APPROVED MEETING MINUTES

January 7, 2016

Judkins Park Station

Schematic Design -
Condition Compliance

Figure 2: updated design to meet condition 1 (above) and condition 2 (below) given by the LRRP during a previous meeting

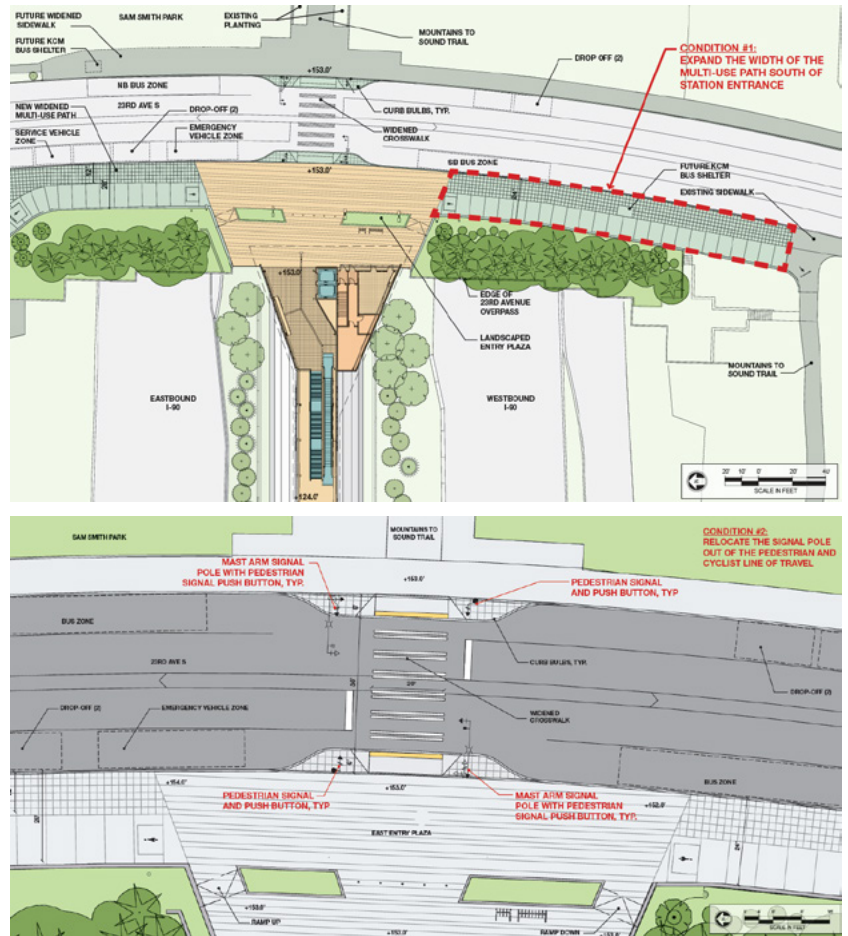
Although the condition to expand the multipurpose pathway was met, the LRRP highly recommended the design team resolve the location of a bus shelter along 23rd Ave S so it does not impede vehicular and pedestrian circulation.

The LRRP has no issue with the updated location of the signal pole.

The LRRP appreciates how the west entry design has evolved to include a head house on the west side of Rainier Ave S. The panel encouraged the design team to reconsider the height of the pedestrian bridge, which is currently lower than the adjacent vehicular bridge, so that it is better integrated with the structure and design of the overall I-90 overpass.

The Panel also encouraged the design team to integrate the stairway west of Rainier Ave S into the surrounding bridge in a way that eliminates the need for a structural column, which is currently supporting the stairway design.

The panel is concerned with the absence of a pedestrian drop off area near the west entry along Rainier Ave S. The LRRP highly recommended ST work with SDOT in designing a safe drop off area near the west entry.

1. Coordinate with Seattle Department of Transportation (SDOT) and King County Metro to plan a resolution for meeting transit, bicycle, and pedestrian circulation needs on Rainier Ave. S near the I-90 overpass. Provide a passenger drop-off area near the Judkins Park Station West Entry along Rainier Ave S
2. Coordinate with LRRP for an administrative review of Hank Willis Thomas' comprehensive art proposal prior to LRRP review of the Design Development phase of the project

1. Better integrate the pedestrian bridge with the new west head house on Rainier Ave S . Strategies to consider include eliminating the support pole underneath the west head house stairs and providing lighting along the pedestrian bridge crossing Rainier Ave S
2. Create a stronger balance between materials used on the sound walls lining the station by:
 - extending the use of a gabion veneer along the entire height of the sound barrier wall
 - Identify strategic points along the sound wall where pedestrians can view the underlying concrete material
3. Extend the feeling of respite created by landscaping around the west entry ticketing area to the station platform, where possible
4. Explore ways to integrate artwork located on the station platform with the surrounding structure

Figure 4: Proposed location for (above) and examples of (below) artwork by Barbara Earl Thomas

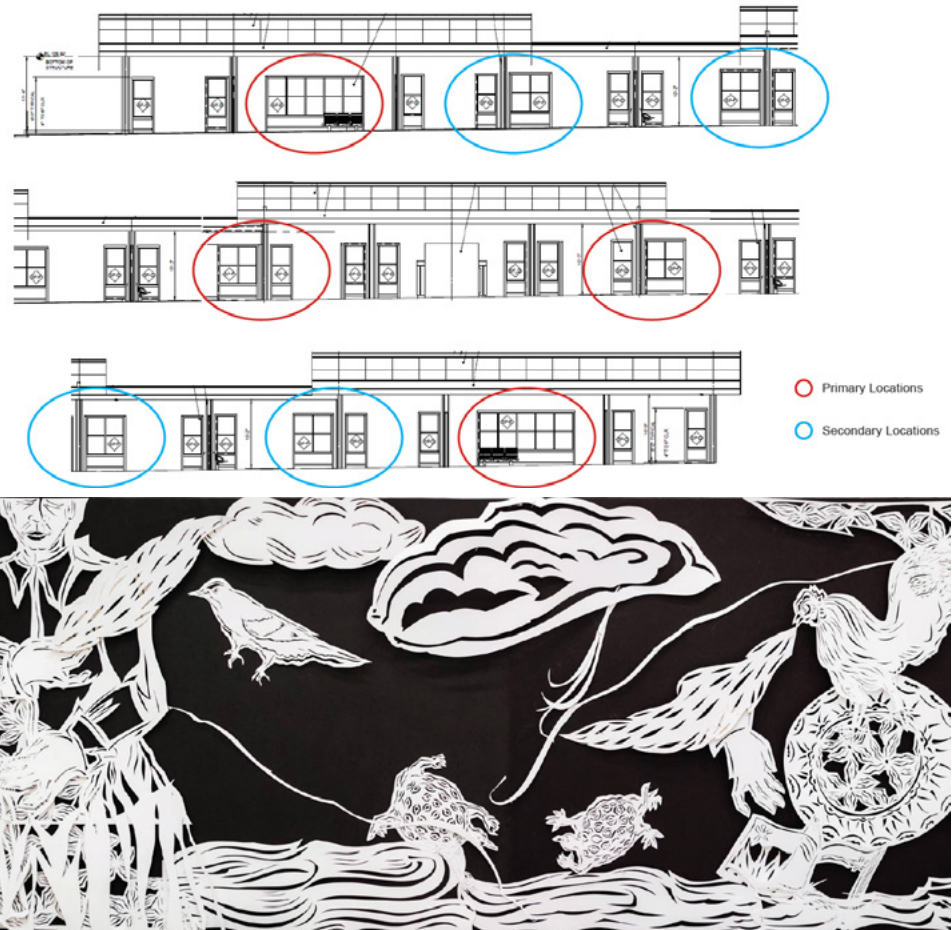
The Panel appreciates the work presented by Barbara Earl Thomas, acknowledging the appropriateness of her artwork within the context of the surrounding neighborhood community. The LRRP agrees Ms. Thomas' work is heading in the right direction and encouraged the use of elements that will further integrate her artwork into the surrounding structure.
